Commercial and HD Starters Difference ‘M Wire’

DSN2075

DSN2076

‘M Wire’

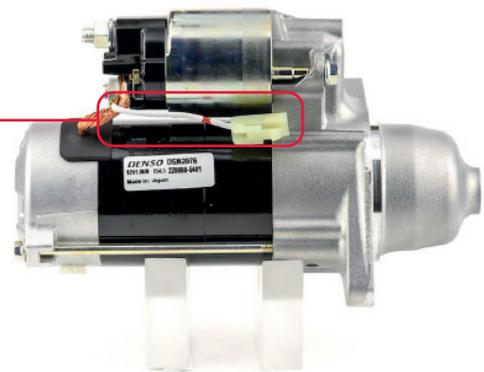
The explanation below describes the difference between the above starters. The difference is that DSN2076 has an ‘M Wire’ — as indicated (above right) — which is a wire with its connector attached to the motor terminal on the starter solenoid, whereas DSN2075 does not have an ‘M Wire’.

The ‘M Wire’ is used to send a signal to another part that is related to the ignition system of the vehicle when the starter motor is activated.

If the end user or the workshop purchase DSN2075 in place of DSN2076, they are able to use the ‘M Wire’ by removing it from the original starter to fit the new one, providing it is in good condition.

CAUTION: Voltage is applied to the 'M Wire', therefore, remove or secure properly if not required.
